SUBJECT: Contract 008066
SR 520, Floating Bridge and Landings Project
Federal Aid No. BR-0520(047)
Change Order No. 180 – September 12, 2014 Project Resolution

CONTRACT NO: 008066 FEDERAL AID NO: BR-0520(047)
CONTRACT TITLE: SR 520 / I-5 TO MEDINA - EVERGREEN POINT FLOATING
CHANGE ORDER NO: 180 09/12/2014 PROJECT RESOLUTION

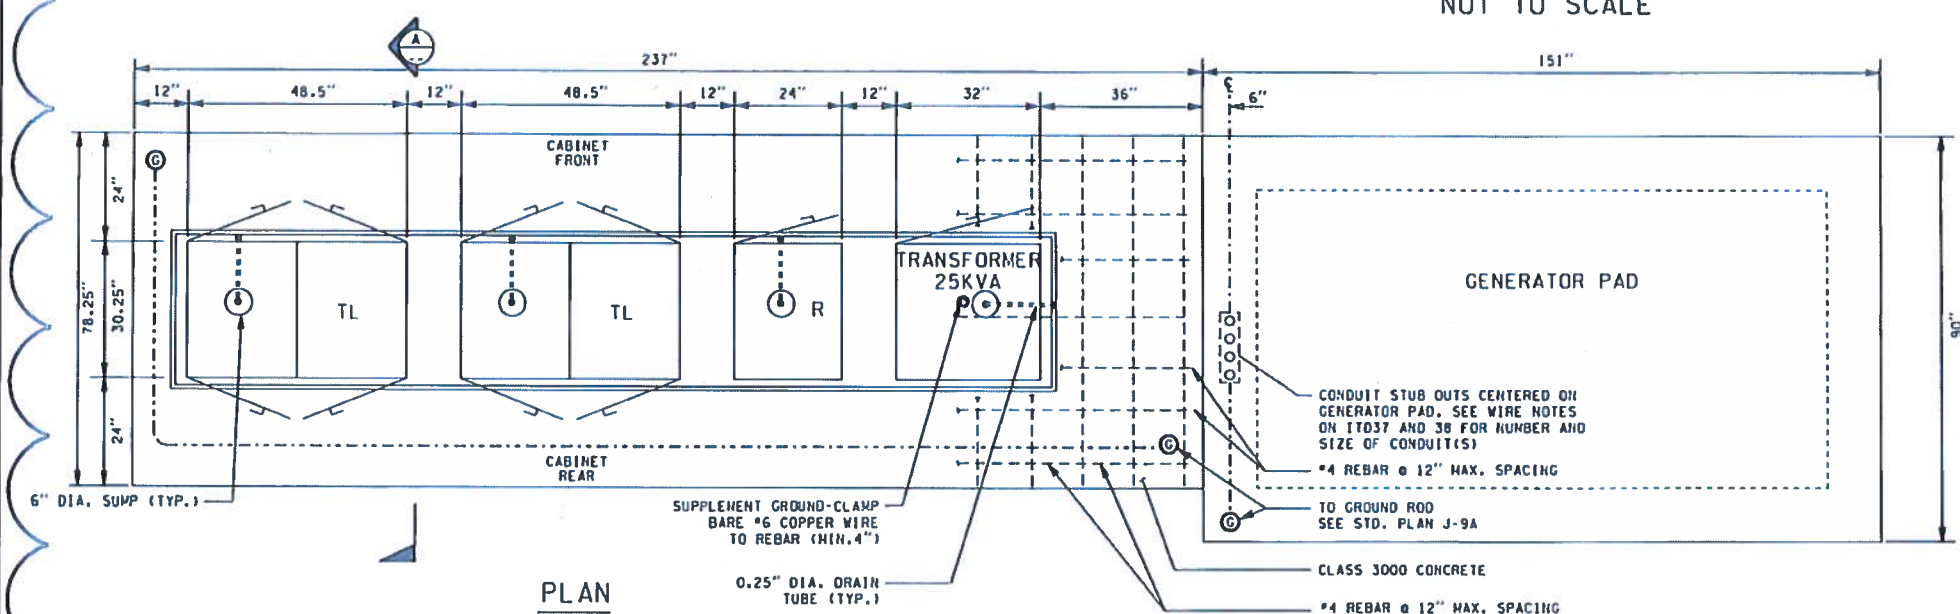
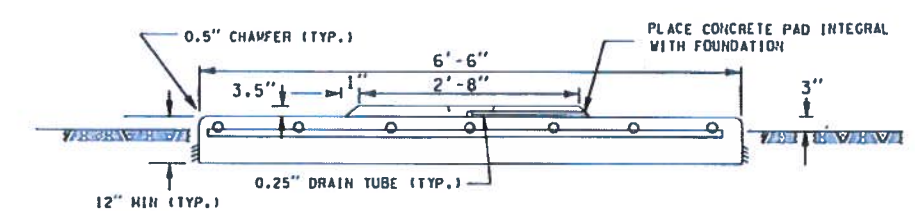
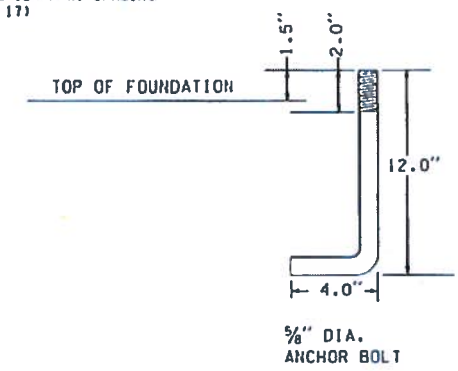
“The concrete for the generator foundation for the tolling structures shall be constructed of concrete Class 4000.

The dimensions for the generator foundation shall be as shown in sheet 11 of 12 of this change order.”

During coordination meetings between the Design-Builder, the WSDOT Project Office, the WSDOT Toll Division, and their Toll Vendor, Telvent, it was determined that the size of the generator pads being built by KGM for the temporary and permanent tolling systems needed to be increased in size to support all of the tolling equipment to be installed by Telvent. In addition, WSDOT requested that KGM increase the strength of the concrete from 3000 psi to 4000 psi to support the proposed equipment.

The dimensions for the generator foundation shall be as shown in sheet 11 of 12 of this change order.

SR FILE NO. SHEET AG7

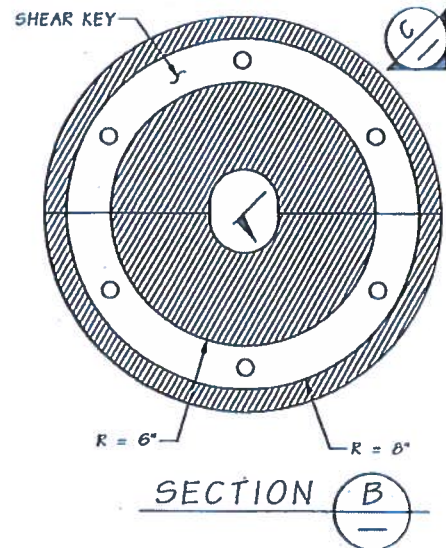
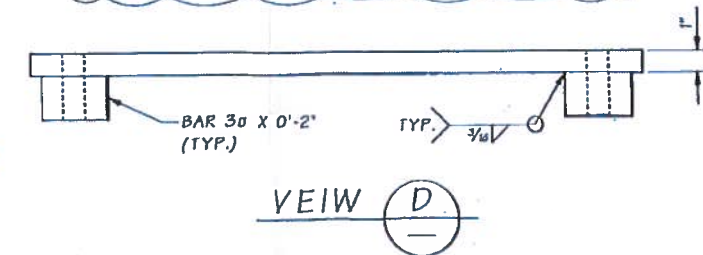
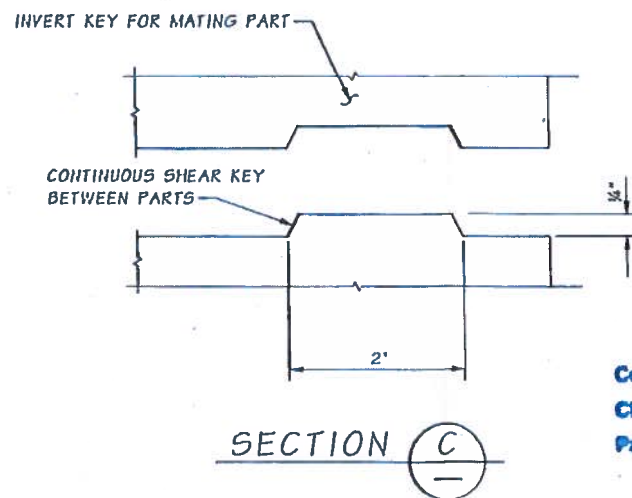
“The bolt hole diameter for the Bushing Keeper Plate on Bridge Sheet No. AG7 of the Outfitting and Assembly Minimum Technical Requirements (Appendix M23) shall be increased from 1-inch to 2-inch as shown on sheet 12 of 12 of 008066 Change Order No. 180. Washers for the keeper plates shall be sized accordingly to account for the 2-inch bolt hole diameter. Anti-seizing compound shall be applied to the threads of the stainless steel keeper plate bolts in accordance with the manufacturer’s written instructions.”

In July 2014, KGM submitted a request for additional compensation (KGM Serial Letter 0575) for work associated with a dimension error on the Appendix M23 plan sheets. These plan sheets showed an incorrect size for the bolts used in the anchor keeper plate.

"The bolt hole diameter for the Bushing Keeper Plate on Bridge Sheet No. AG7 of the Outfitting and Assembly Minimum Technical Requirements (Appendix M23) shall be increased from 1-inch to 2-inch as shown on sheet 12 of 12 of 008066 Change Order No. 180. Washers for the keeper
